PROJECT: City of Ferndale Cherry Street Sidewalk Project
(Schedule A and Schedule B) and Pioneer Park
Sidewalk Project (Schedule C)

ADDENDUM NO. 1
To the Contract Provisions for
CITY OF FERNDAL, WASHINGTON

Cherry Street Sidewalk Project, City Project No. ST2015-09 (Schedule A and Schedule B)
Pioneer Park Sidewalk Project, City Project No. PA2018-01 (Schedule C)

DATE 7/2/2018
SHEET 5 of 17

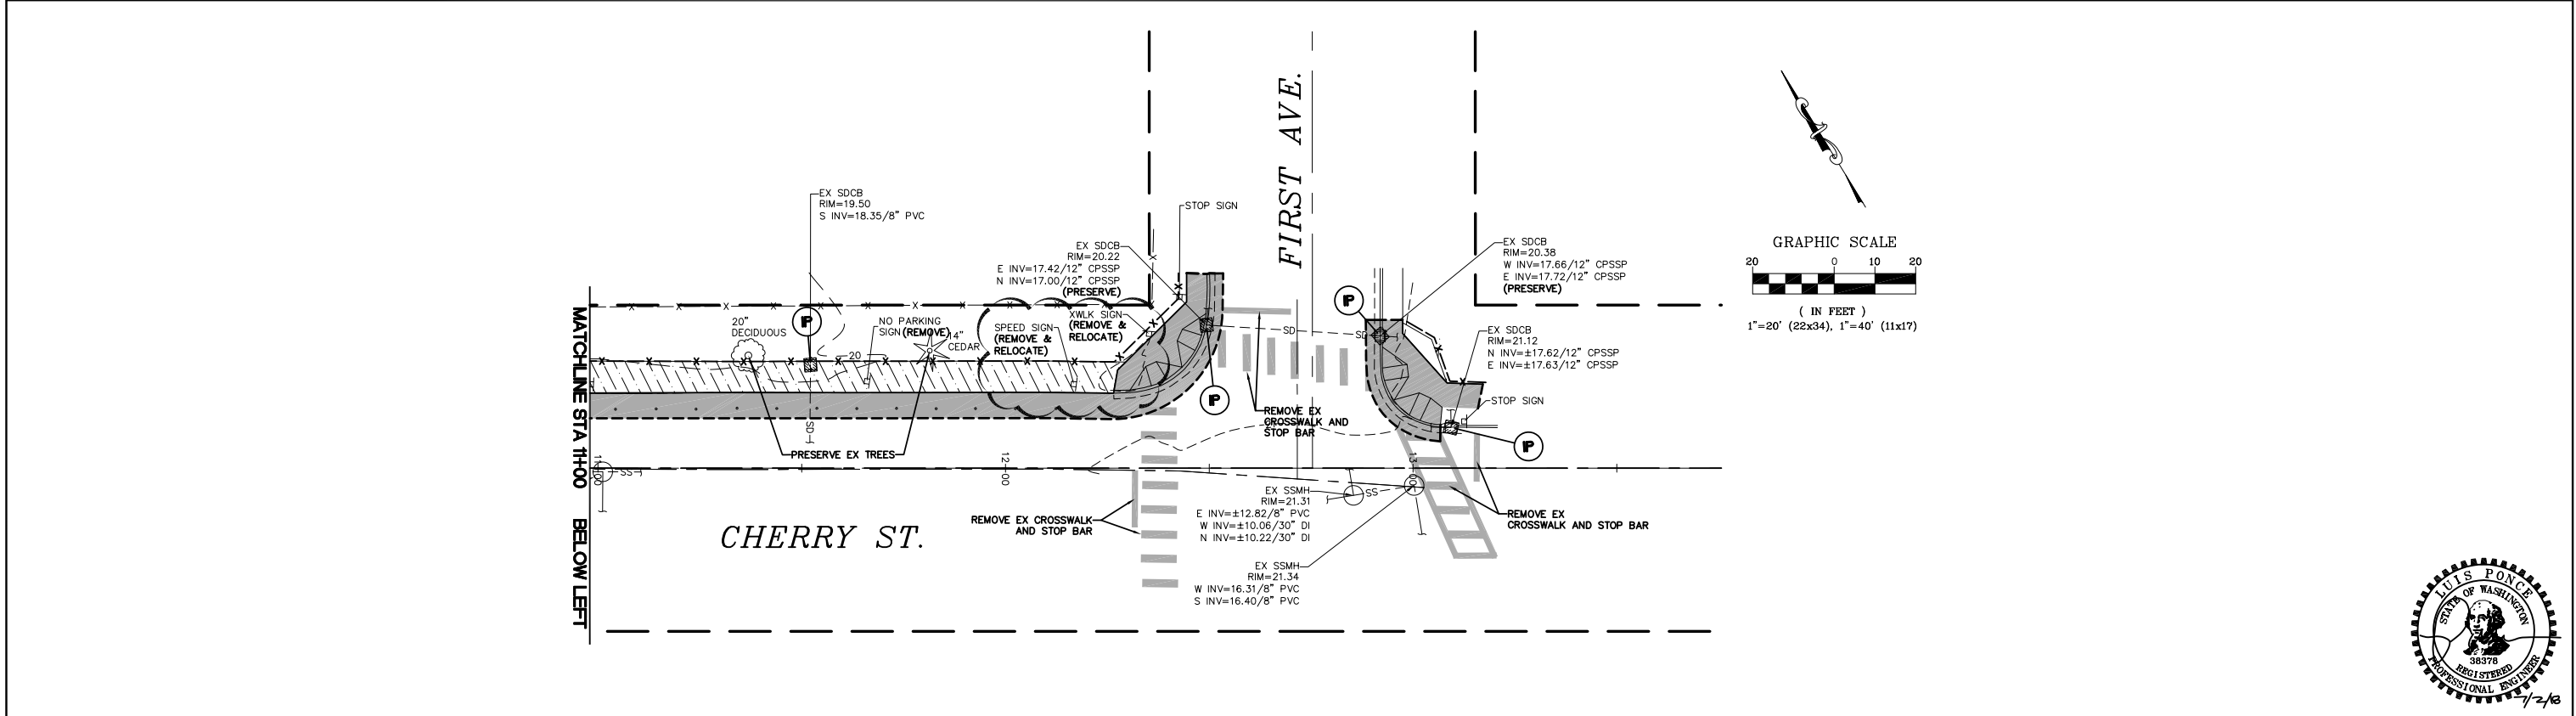
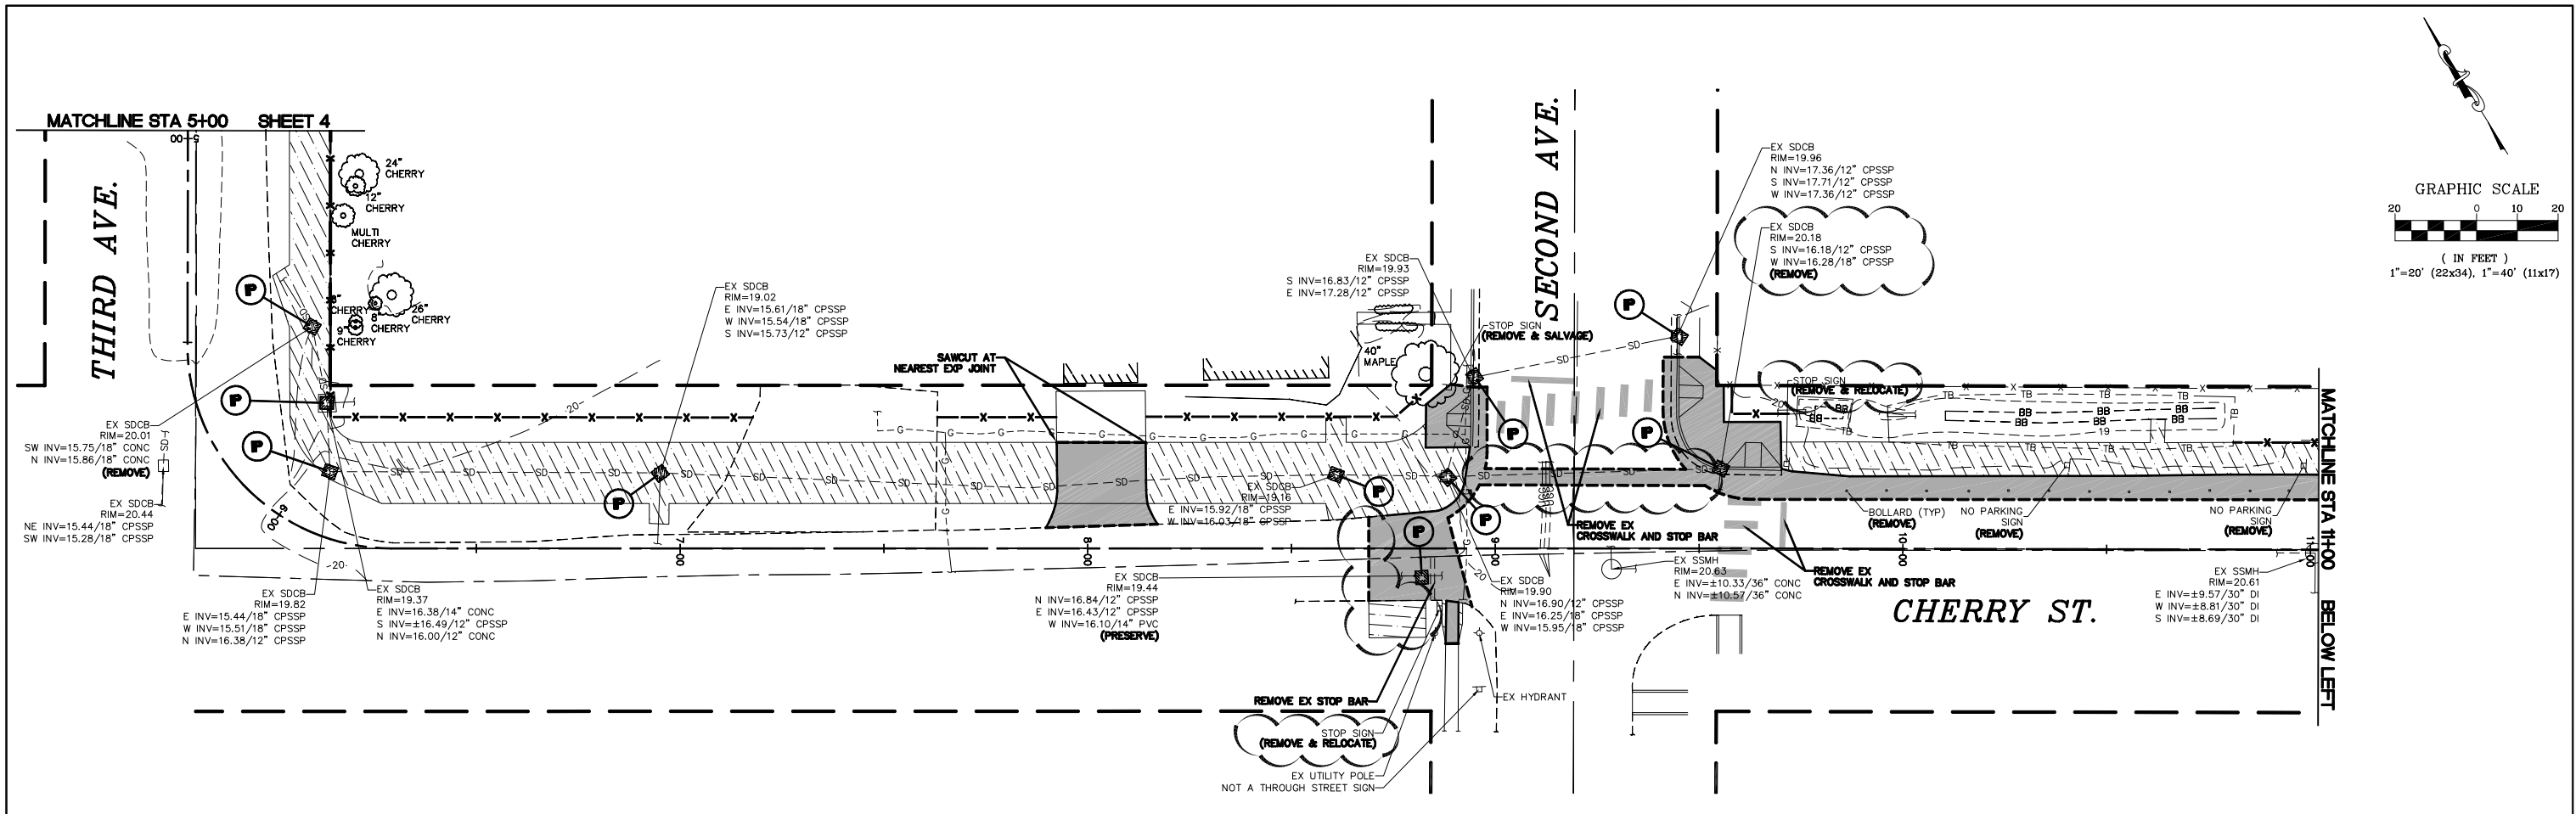
Schedule A and Schedule B, Plan Sheet 5

Demolition areas revised and sign/storm notes revised as shown.

10

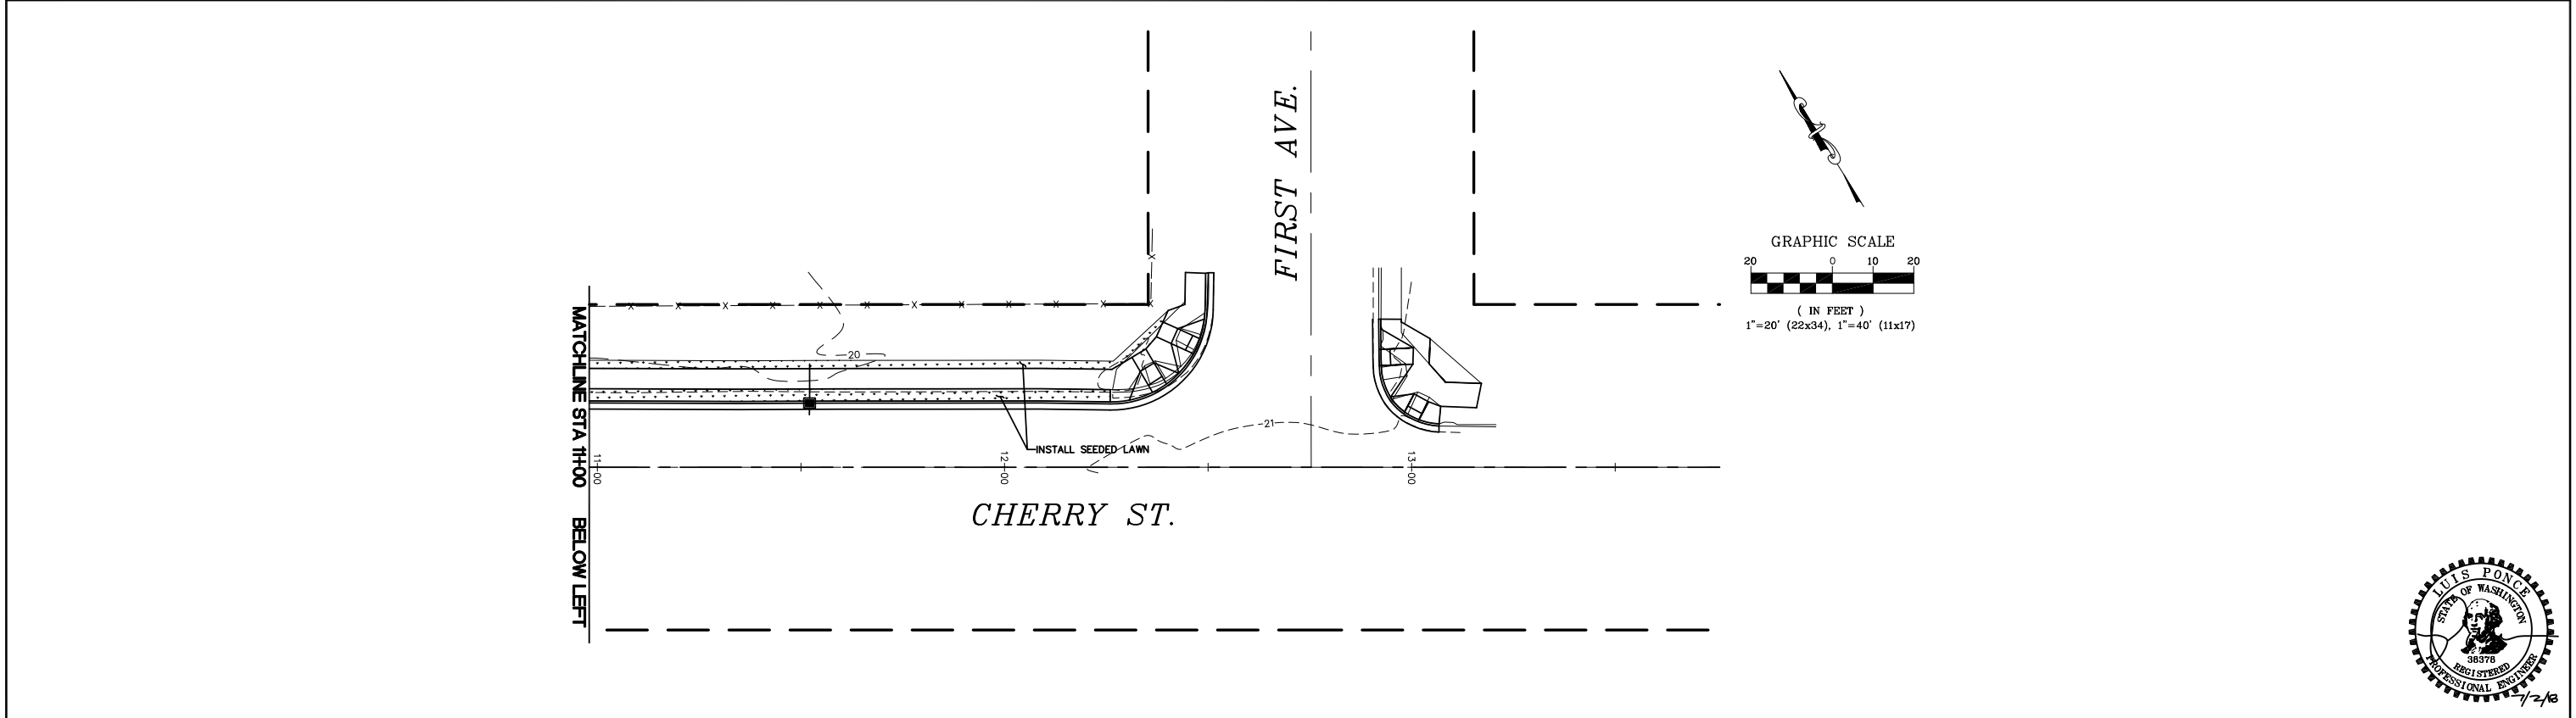
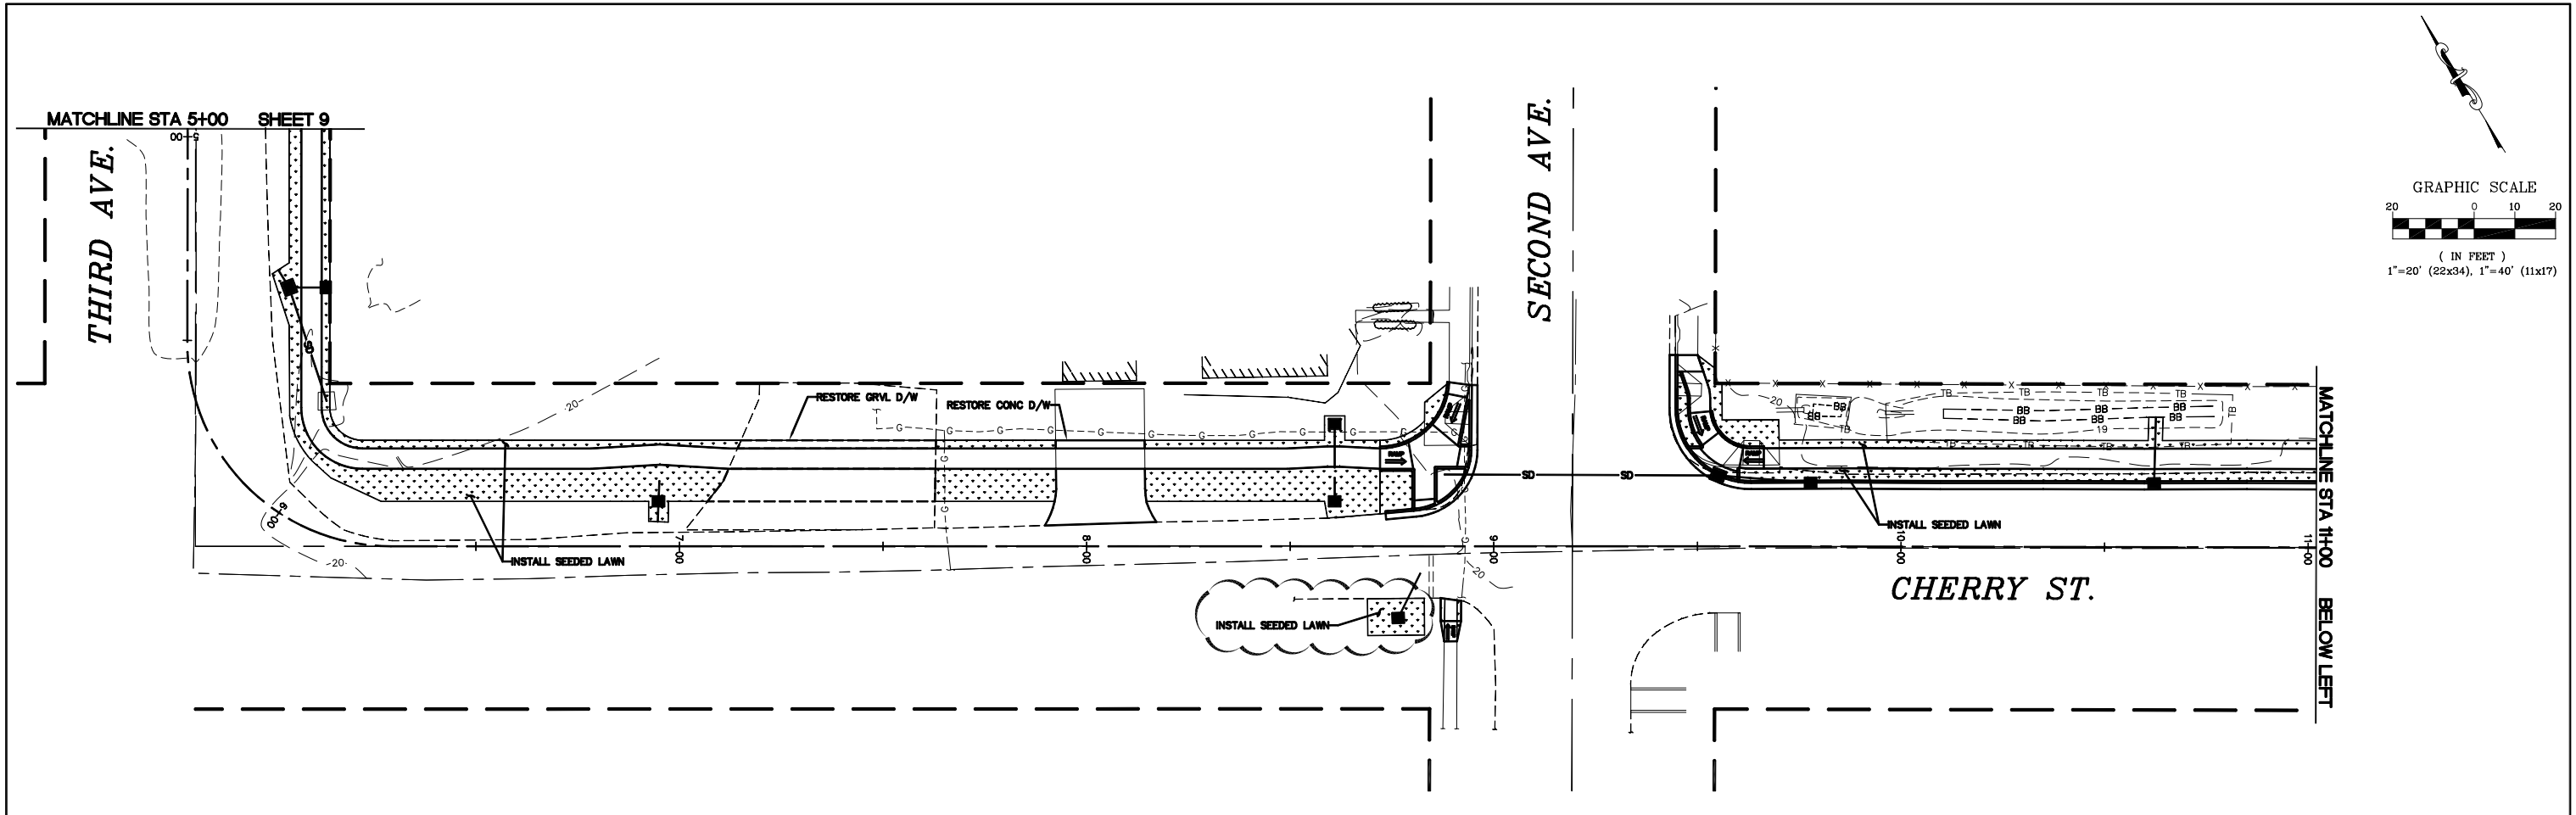
Schedule A and Schedule B, Plan Sheet 10

Seeded lawn added at relocated catchbasin as shown.
